# UNITED STATES PATENT AND TRADEMARK OFFICE

APPLICATION NO.	FILING DATE	FIRST NAMED INVENTOR	ATTORNEY DOCKET NO.	CONFIRMATION NO.
10/762,021	01/20/2004	Jong Cheol Jang	GRANP3.003AUS	3989
20995	7590	11/23/2004	EXAMINER	
KNOBBE MARTENS OLSON & BEAR LLP			WELCH, GARY L	
2040 MAIN STREET			ART UNIT	
FOURTEENTH FLOOR			PAPER NUMBER	
IRVINE, CA 92614			3765

<b>Office Action Summary</b>	<b>Application No.</b> 10/762,021	<b>Applicant(s)</b> JANG, JONG CHEOL	
	<b>Examiner</b> Gary L. Welch	<b>Art Unit</b> 3765

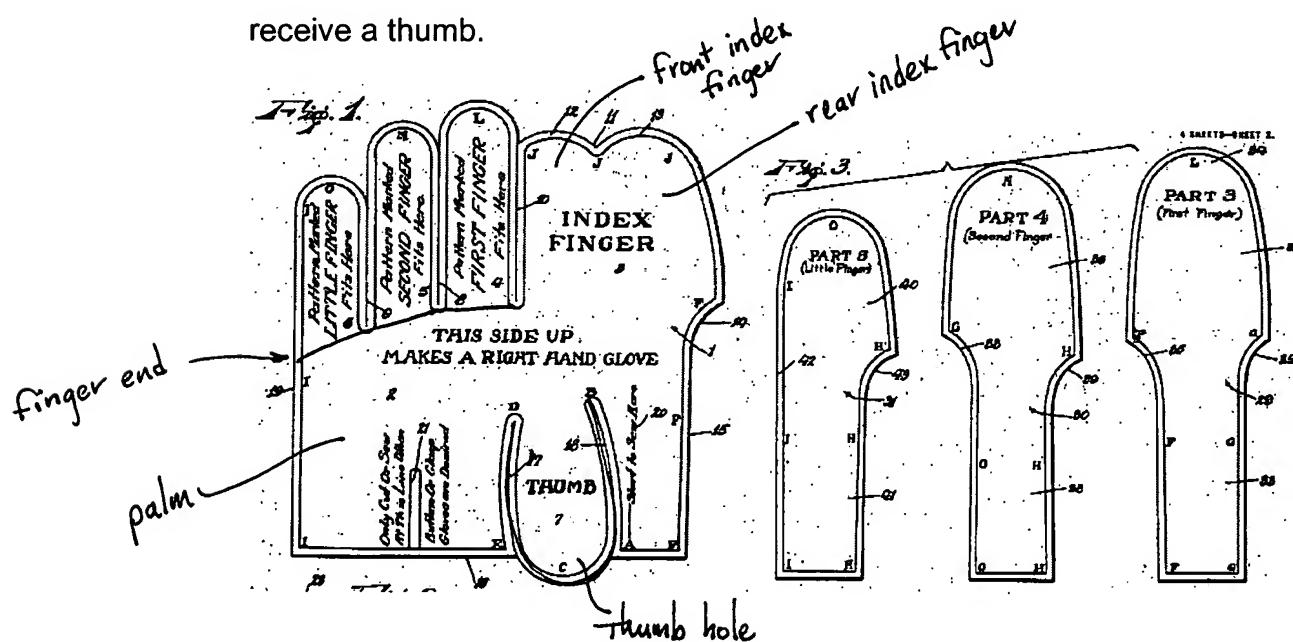
7. Claims 1-8 are rejected under 35 U.S.C. 102(b) as being anticipated by Ruddell (U.S. 1,427,419).

Ruddell discloses a five-fingered, comprising:

a palm piece having a front index finger portion, a rear index finger portion, a finger end and a thumbhole, wherein the front and rear index finger portions are integrally formed; a backhand piece (Figure 3), having a rear middle finger portion, a rear third finger portion and a rear little finger portion which are integrally formed, coupled to the rear index finger portion of the palm piece; a finger piece, having a front middle finger portion, a front third finger portion and a front little finger portion which are integrally formed, coupled to the finger end of the palm piece, wherein the front and rear index finger portions are together configured to receive an index finger, wherein the front and rear middle finger portions are together configured to receive a middle finger, wherein the front and rear third finger portions are together configured to receive a third finger, and wherein the front and rear little finger portions are together configured to receive a little finger; and a thumb piece coupled to the thumbhole of the palm piece and configured to receive a thumb.

With regard to claim 4, as best understood, the finger end of the palm piece is positioned upward to the front index finger portion with a cutting line of the finger piece moved inward so as to make the length of the finger portions shortened (see above Figure).
